PROJECT NO: 3030-02-72	HWY: STH 67	COUNTY: DODGE COUNTY	PROJECT OVERVIEW	SHEET	E
------------------------	-------------	----------------------	------------------	-------	---

PLAN DETAILS - STH 67

PROJECT NO: 3030-02-72	HWY: STH 67	COUNTY: DODGE COUNTY	PLAN DETAILS - STH 67	SHEET	E
------------------------	-------------	----------------------	-----------------------	-------	---

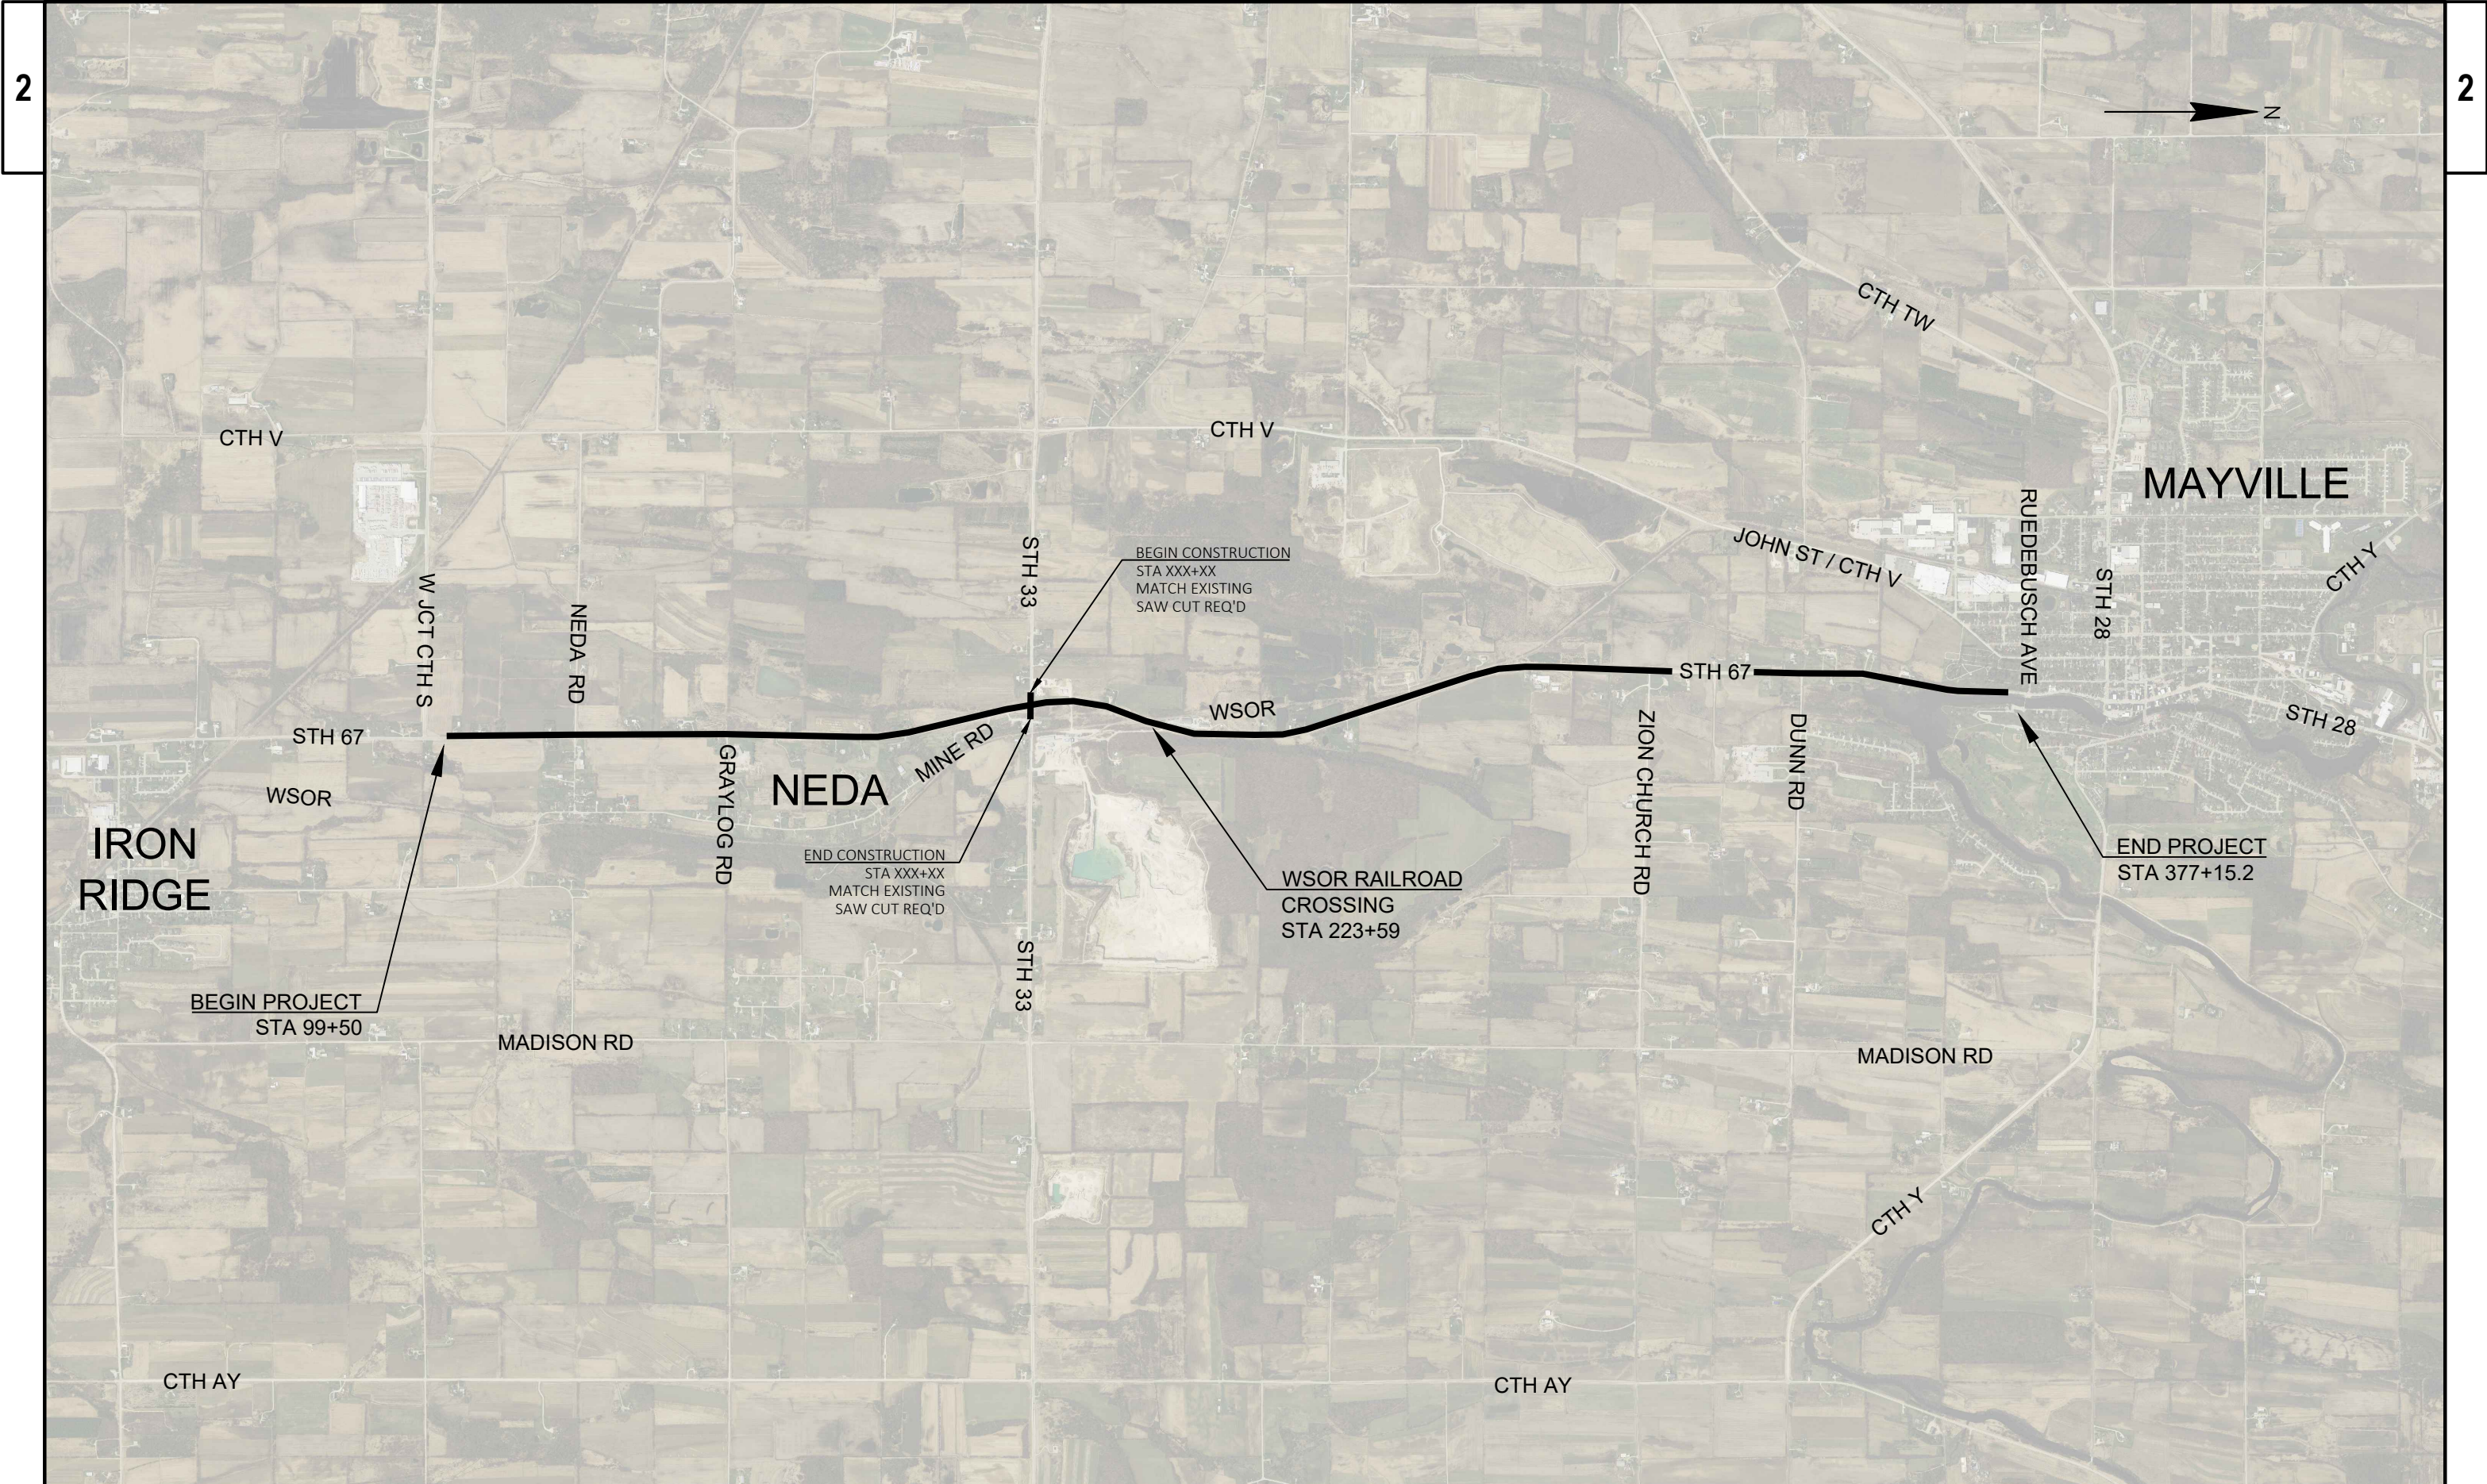
Revise per 8.21.19
DT1078-Utility List.

Increase Diggers
Icon

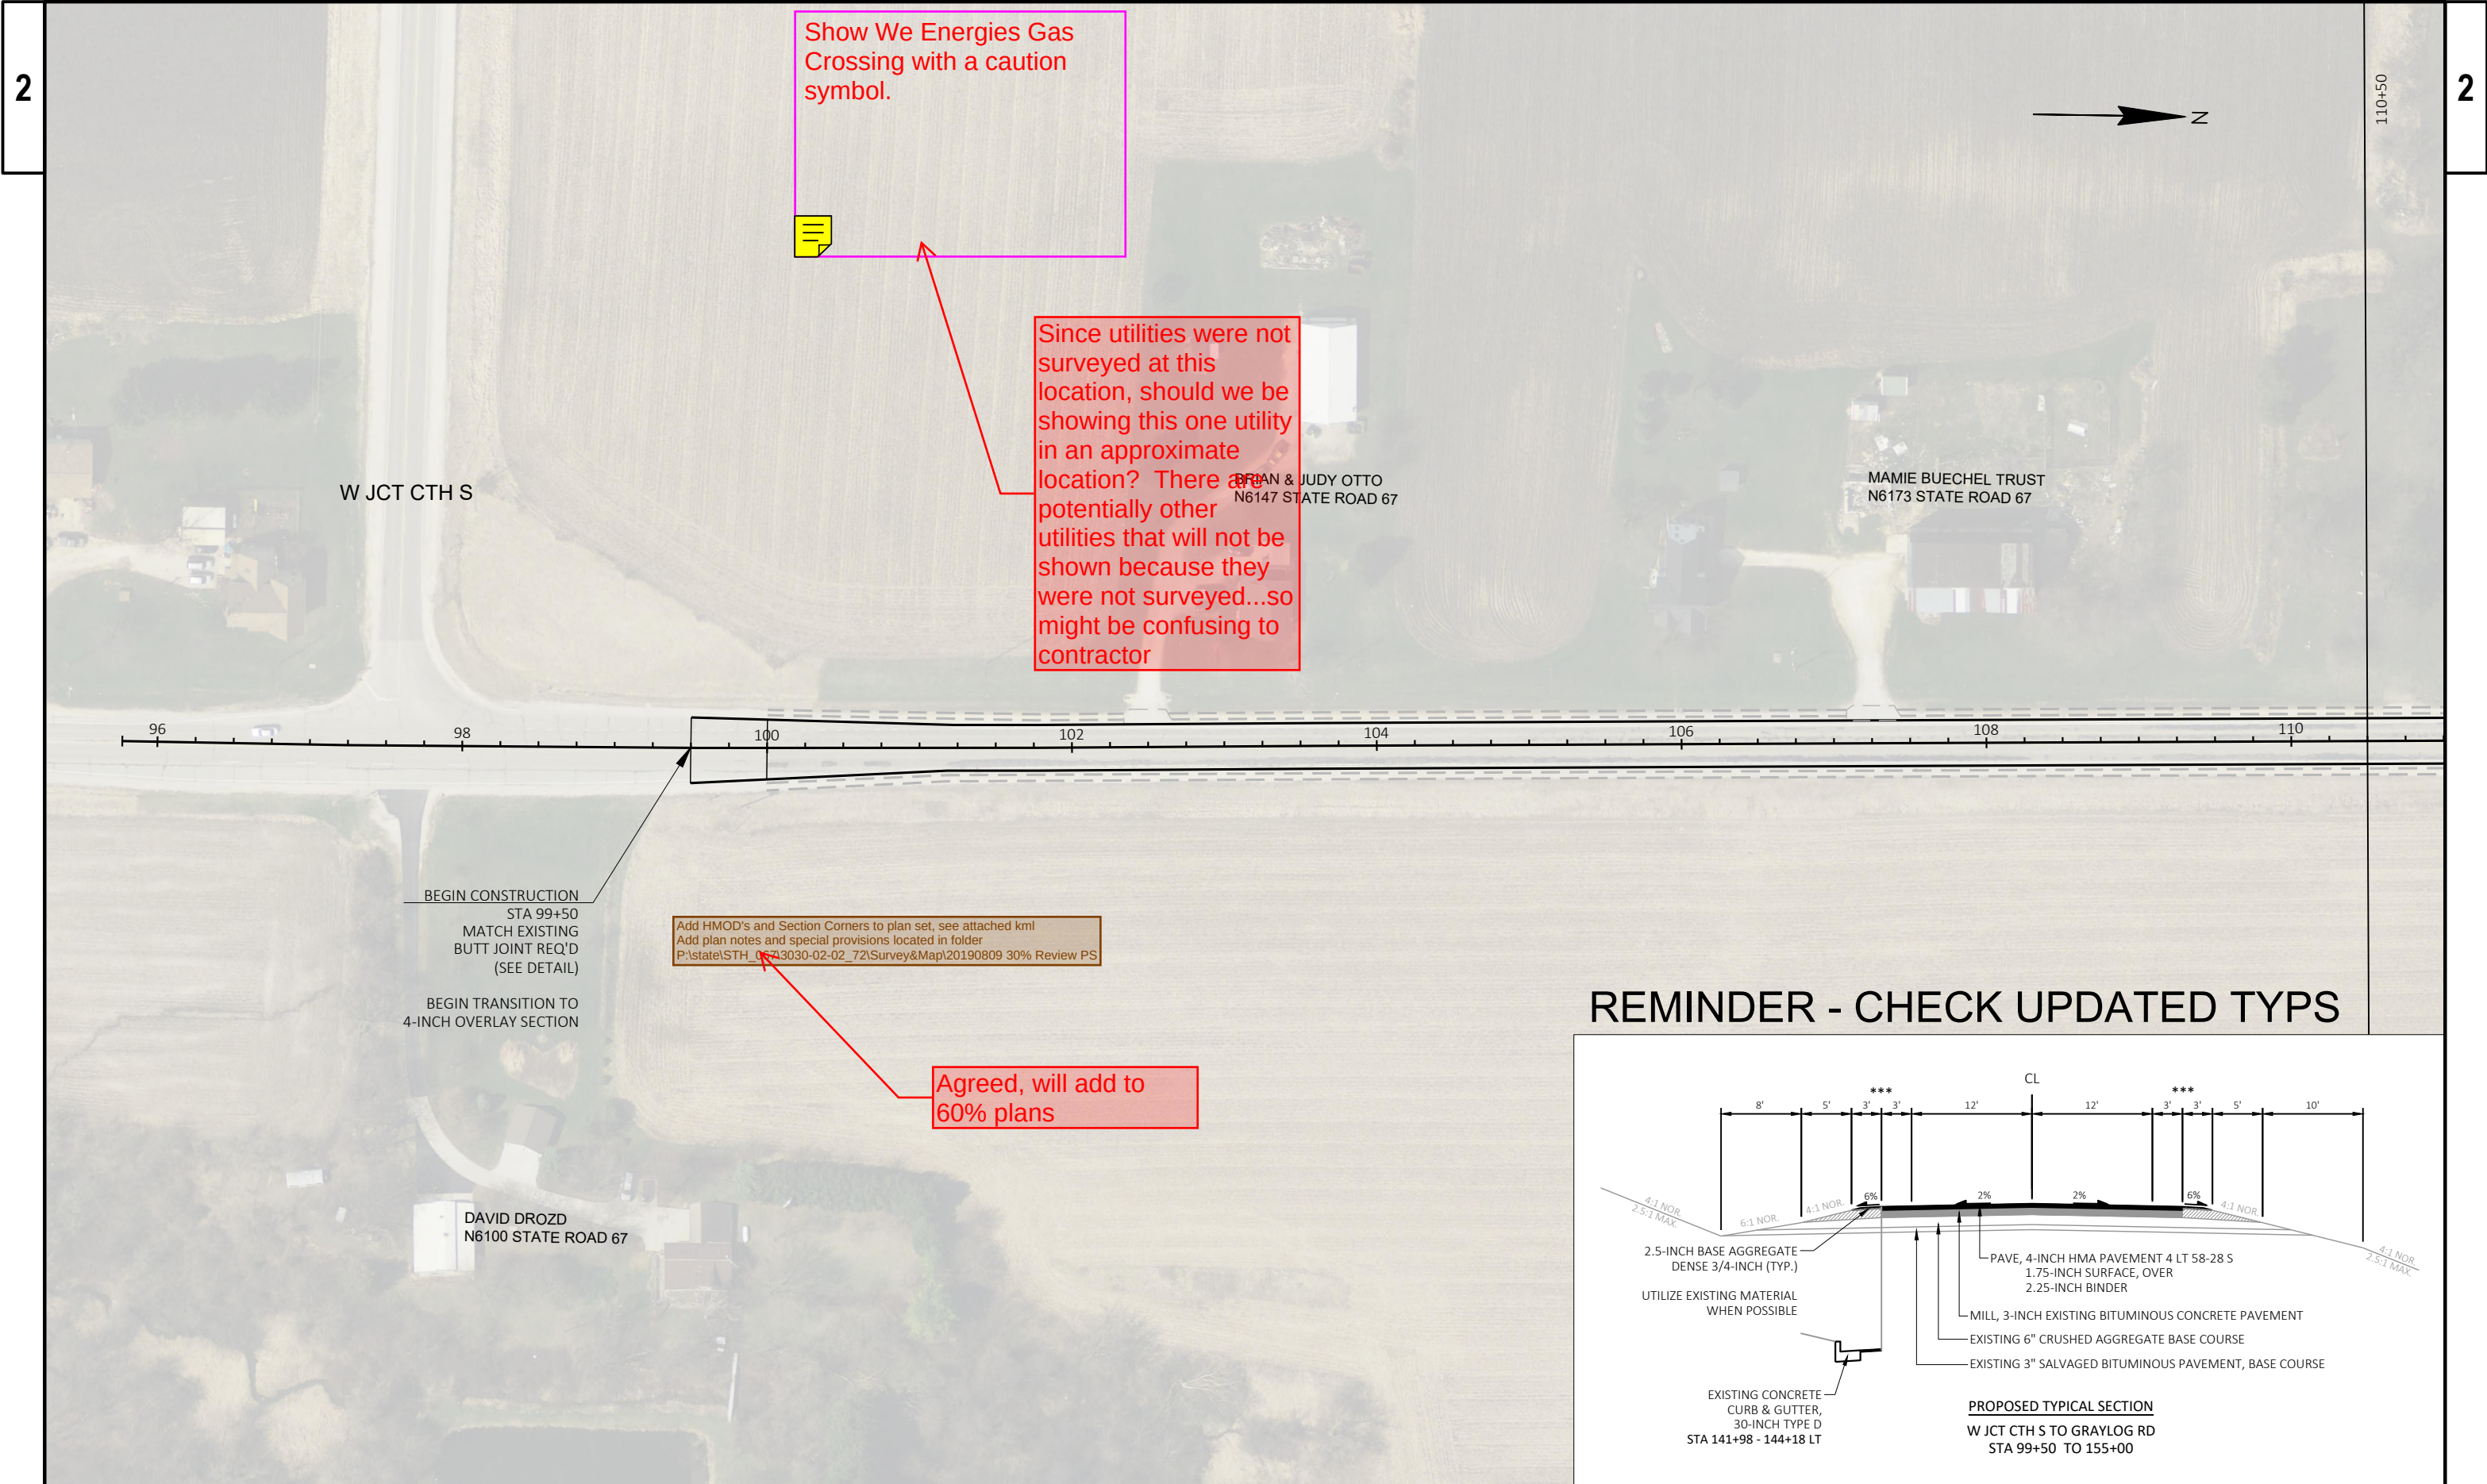
Show We Energies Gas Crossing with a caution symbol.

Since utilities were not surveyed at this location, should we be showing this one utility in an approximate location? There are potentially other utilities that will not be shown because they were not surveyed...so might be confusing to contractor

Add HMOD's and Section Corners to plan set, see attached kml
Add plan notes and special provisions located in folder
P:\state\STH_06\3030-02-02_72\Survey&Map\20190809_30% Review PS

Agreed, will add to 60% plans

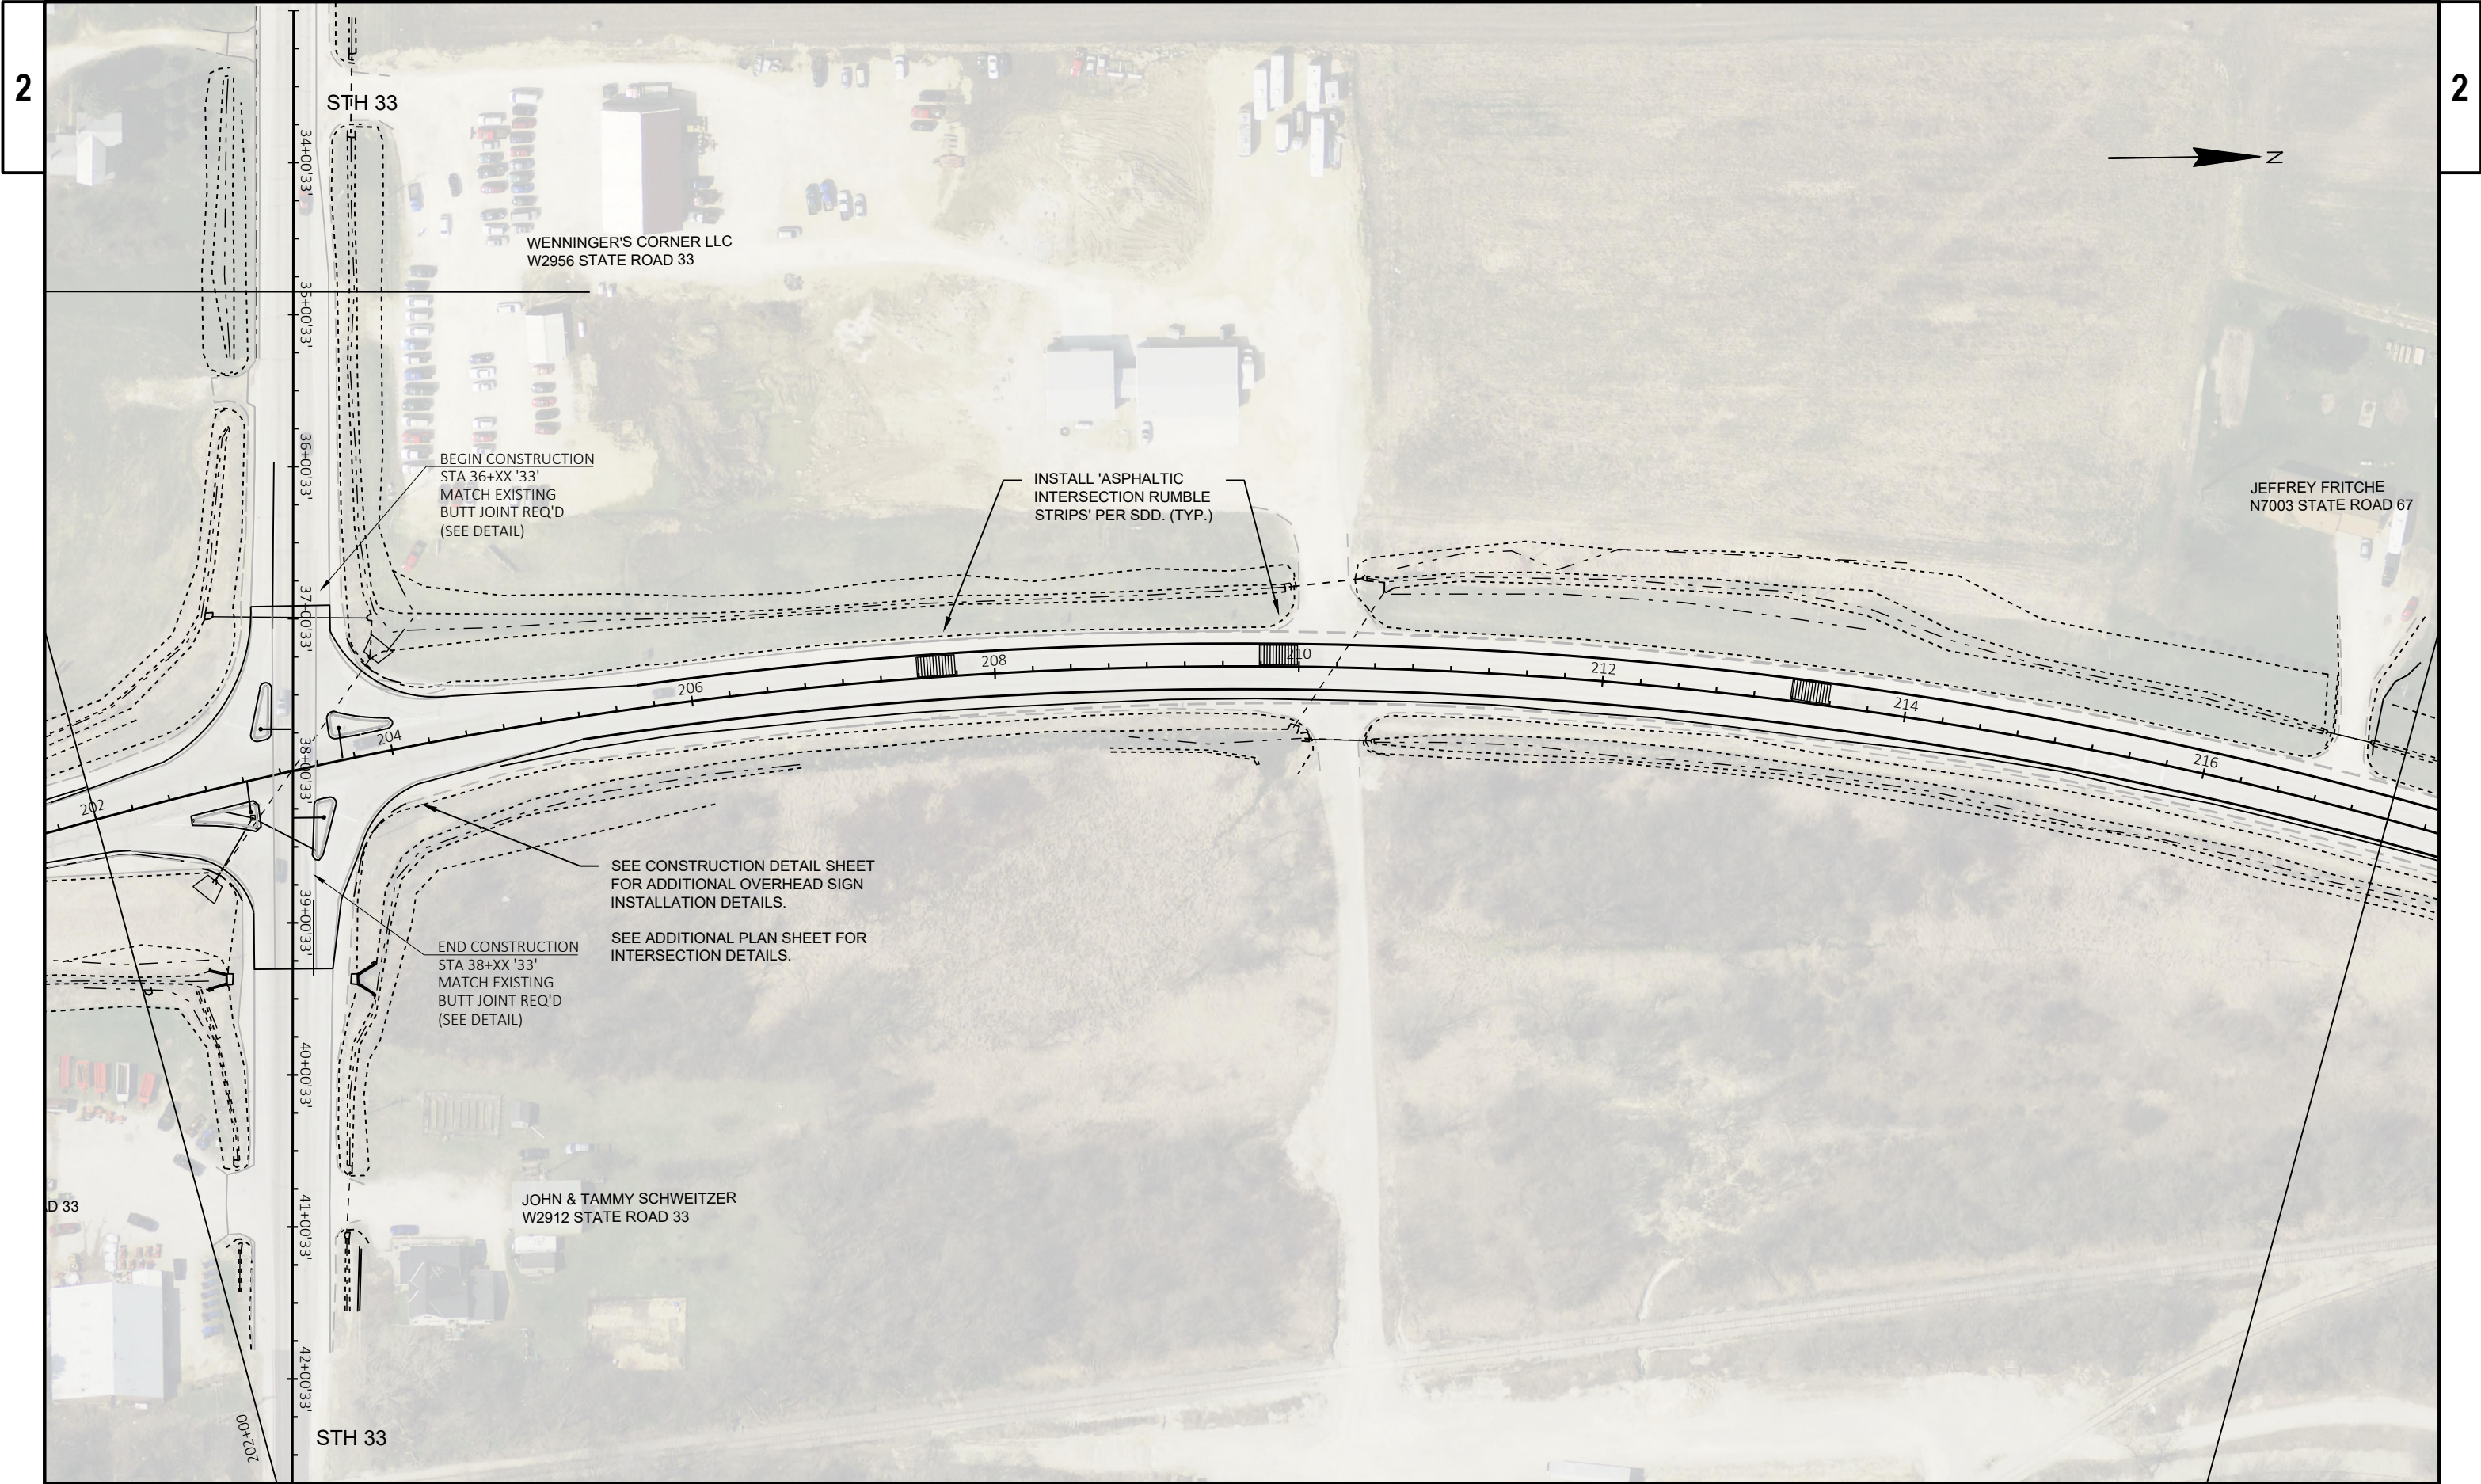
Show We Energies Gas Crossing with a caution symbol.

Dodge County Pete T. - The near rumble strip falls in the middle of a driveway. Do you typically install them there? I know it is based on approach speed, but maybe a little leeway could be allowed?

Yes this can be adjusted to be just before the driveway
